Members of the Board of Park Commissioners,

December 12, 2018

It is not appropriate to approve the James Madison Park Master Plan tonight. Your referral is the appropriate, positive action, reflecting the importance and legacy impact this plan will have on the entire city. As an architect in my 11th year of service on city committees, we are being asked to review an over 200-page document, dated today, that has been compiled over the last year. Prior to its posting on Friday, stakeholders were provided different documents on the website that have been removed. Your 2016 Statement of Policy and Guidelines for Master Plan Activities within the Madison Park System **requires you ensure individual park master plans are consistent with the most recently adopted [City of Madison Park and Open Space Plan](#) and [Comprehensive Plan](#)**. Both plans have been recently updated and adopted, by this Commission at the end of October and by the Common Council in August, respectively. I have found a draft of the adopted copy of the Park and Open Space Plan available online. **This individual park master plan cannot compromise goals in adopted plans of community members citywide.**

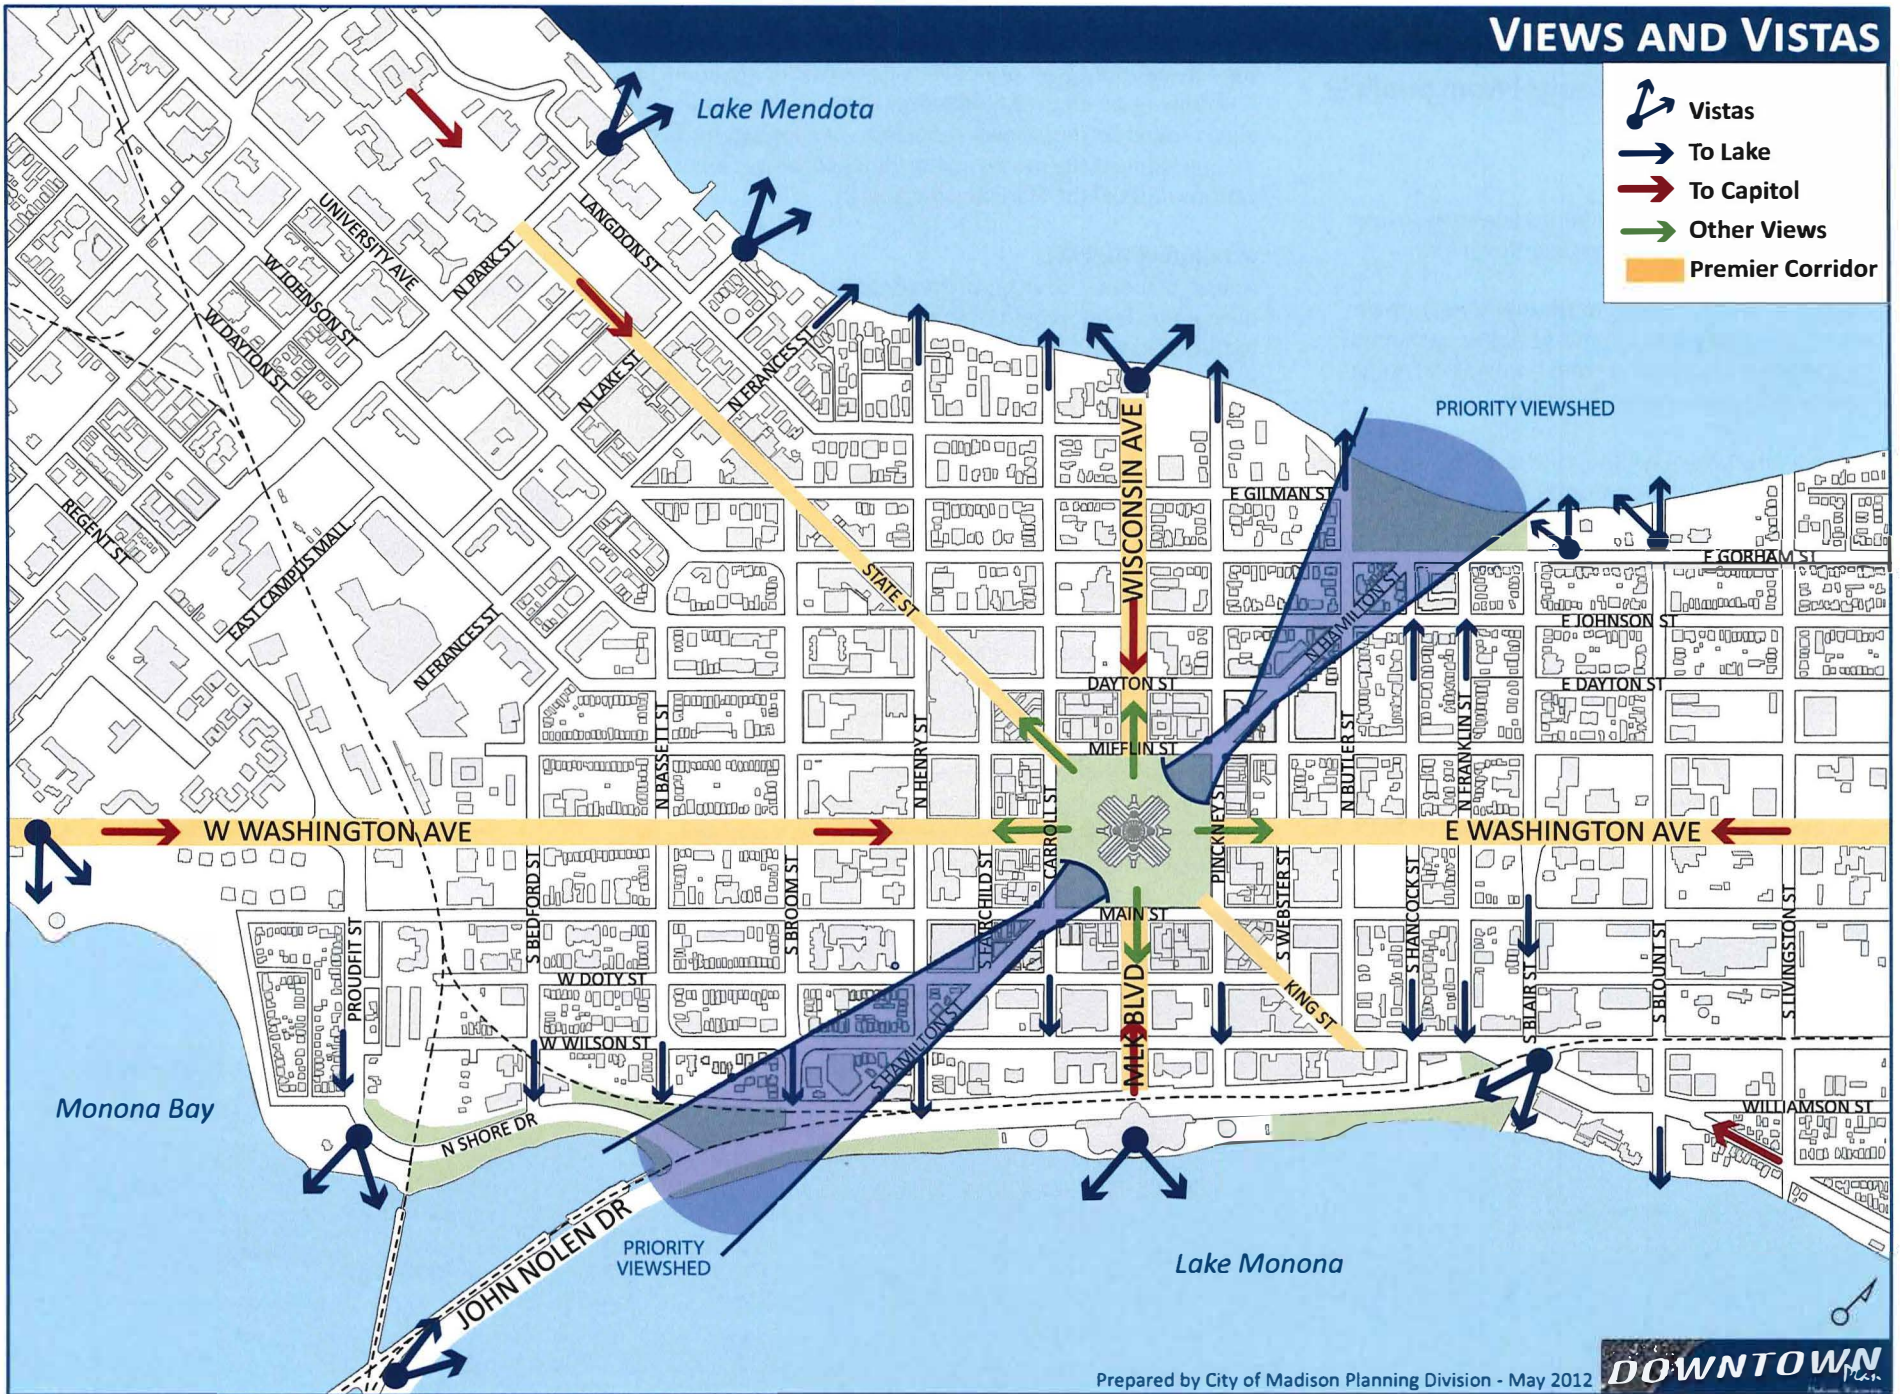
The second issue is the unfortunate location and size of the parking. The location disregards the environmental sustainability goal of the master plan by greatly expanding the surface area required for a similar number of stalls. Some comments have suggested using permeable pavement, but the current technology does not provide permeability over a long term without appropriate maintenance. Furthermore, the placement of the parking at the narrowest spot in the park puts it where it disproportionately reduces the greenspace between Gorham St and the lake.

The proposed location of the parking presents a visual barrier between Gorham St and the lake. This barrier reduces the aesthetic value of the park for commuting pedestrians, bicyclists and motorists. While some of the parking is lowered below sidewalk grade, it still presents a large visual and functional discontinuity between the park boundary and the greenspace. Our goal should be to welcome people into the park with few or no barriers.

The configuration of the proposed parking will not improve safety or reduce the deleterious activities we are currently experiencing in JMP. The entrance and exit on Gorham St will promote cruising through the parking area and more drive-by transactions or incidents. With cars blocking the view between the park and the street, it will be easier for young children to disappear behind cars and wander into the parking area or worse into the street.

Clearly we need some parking for the park shelter, the boat house, and for Gates of Heaven. In addition to a limited number of parking stalls in the park, we can easily add 10 stalls on Butler St and we can designate areas on Gorham St for accessible parking only. The front door to Gates of Heaven is about 300 m or a 4-minute walk to the nearest municipal parking garage. We do not want the Parks Division to be in competition with the Parking Utility.

An easy solution would be to eliminate the parking along Gorham St, to reduce the parking behind Gates of Heaven, and to provide a few stalls at the new shelter. This would require revisiting the neighborhood's proposal for addressing the safety issues behind Gates of Heaven.
